RECOMMENDED SERVICE BULLETIN

RSB 40-083

Replacement of steel pin of door handle mechanism of canopy and passenger door with an improved design.

WORK INSTRUCTION

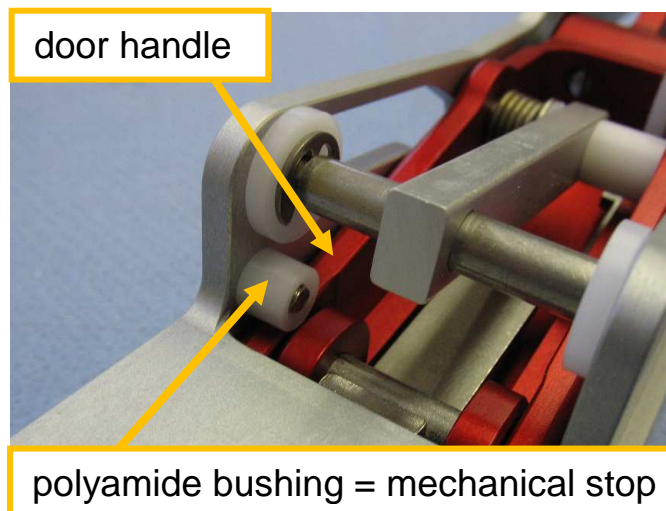
| 4 | Remove the 2 circlips as shown in the pictures blow.  |
| 5 | Remove the steel pin, the polyamide distance bush and the polyamide washer from the door handle mechanism frame. |

Adjust the length of the compression gas spring. Make sure that the polyamide bushing defines the mechanical stop of the red aluminum door handle as shown in the picture below.

Note: The mechanical stop of the red aluminum door handle must not be defined by the internal stop of the compression gas spring.

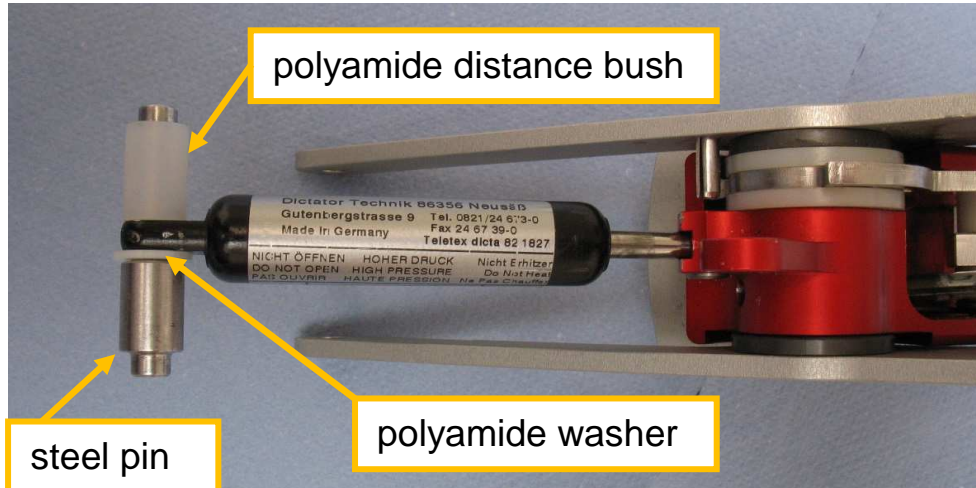
Prepare the new steel pin for installation into the door handle mechanism frame:

- Move the polyamide washer onto the new steel pin.
- Move the steel pin through the eye end of the compression gas spring.
- Move the polyamide distance bush onto the steel pin.

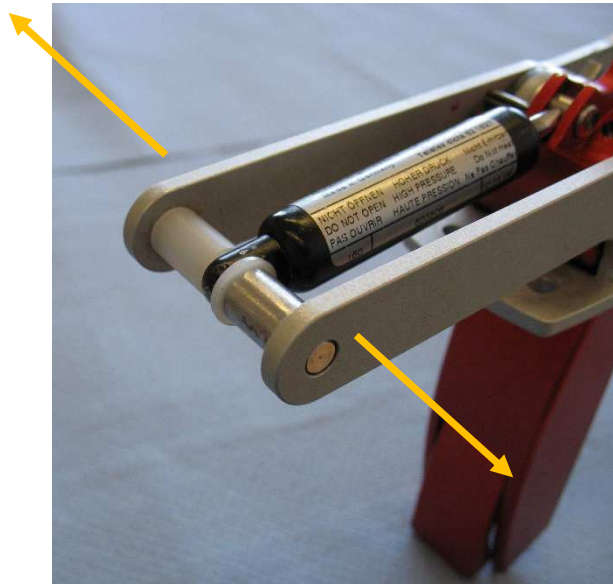
Install the new steel pin with the polyamide washer and the polyamide distance bush to the door handle mechanism frame:

- Move the steel pin into position.
- Carefully bend the side parts of the door handle mechanism frame away from each other as shown by the yellow arrows in the picture below so that the steel pin can snap into the holes of the side parts of the door handle mechanism frame.

Caution: Bend the side parts of the door handle mechanism frame away from each other only as far as necessary. If the side parts are bent too much and permanently deformed, the whole door handle mechanism must be replaced.
